Pathfinder Generating Station  
Docket No. 30-05004  
License No. 22-08799-02

Response to Request for Additional Information Regarding License Termination of  
Pathfinder Facility Located in Sioux Falls, South Dakota License 22-08799-02

**REQUEST FOR ADDITIONAL INFORMATION**  
PATHFINDER GENERATING STATION  
FINAL STATUS SURVEY REPORT DOCKET NO, 030-05004

# Survey Package 001 – Effluent Discharge Pathway Sample Locations

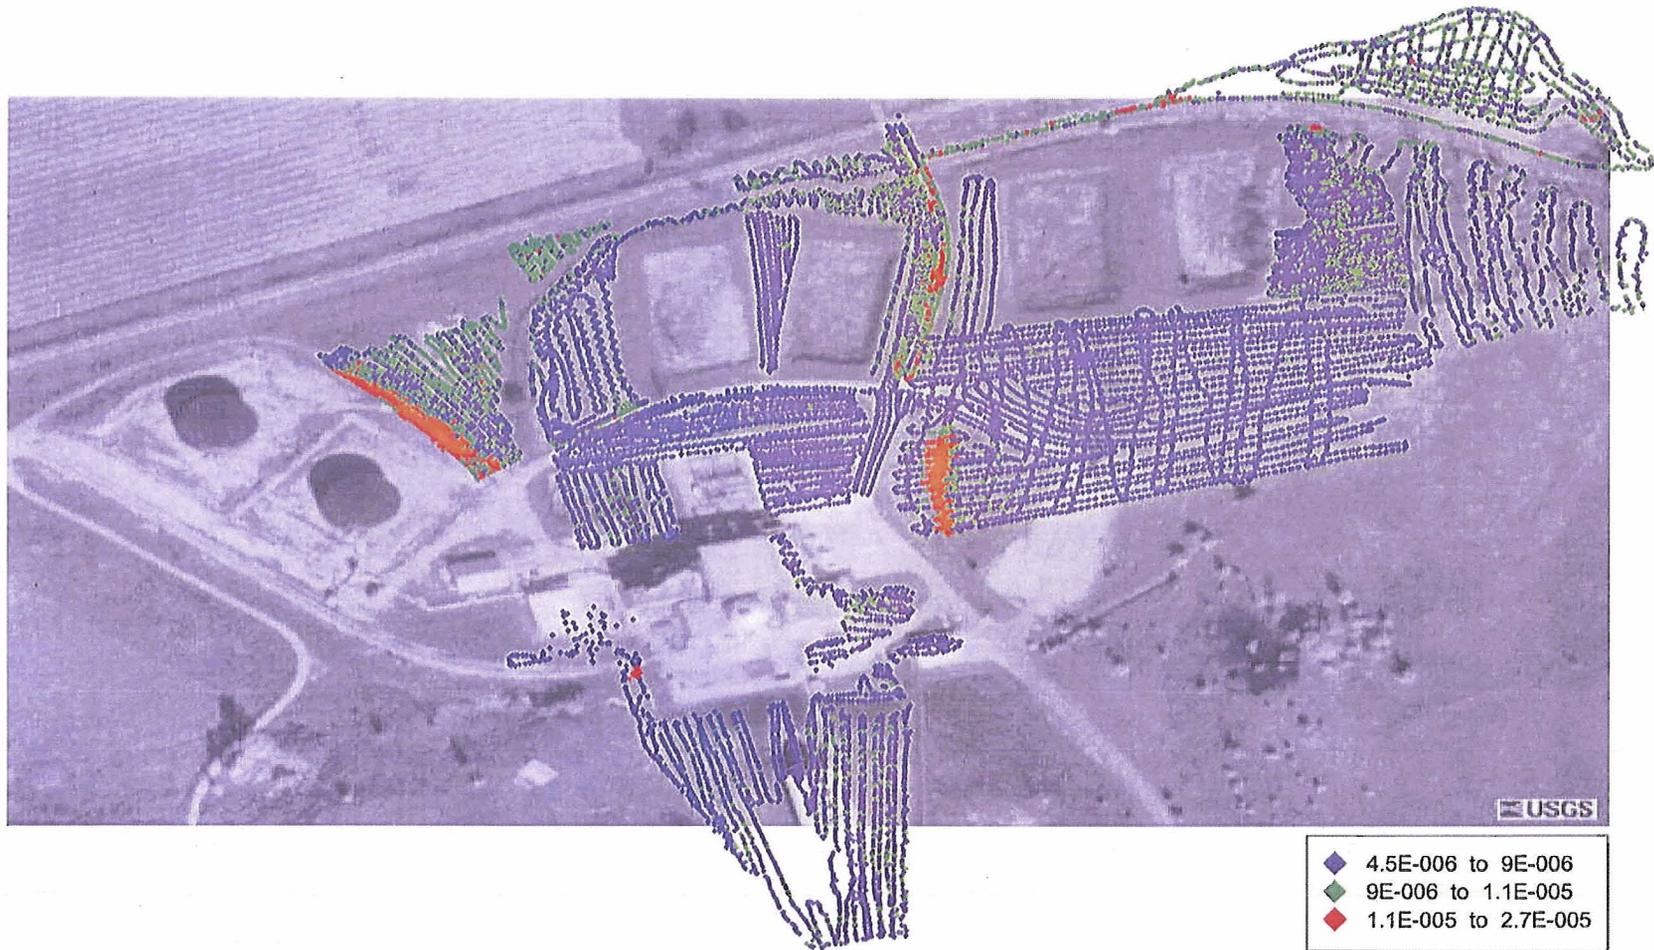
Sample locations can not be determined from the four Sample Location Maps provided for Packages 1-4 in Appendix 1 (Book 2 of 5) due to poor resolution of these maps. Please provide clearer or more detailed maps for each package with visible indication of the locations of the samples.

*Copies of the requested maps are provided in Enclosure 4.*

Replacement Sample Location Maps for Survey Packages 1-4 follow this page. The following maps provide detail regarding the sample locations.
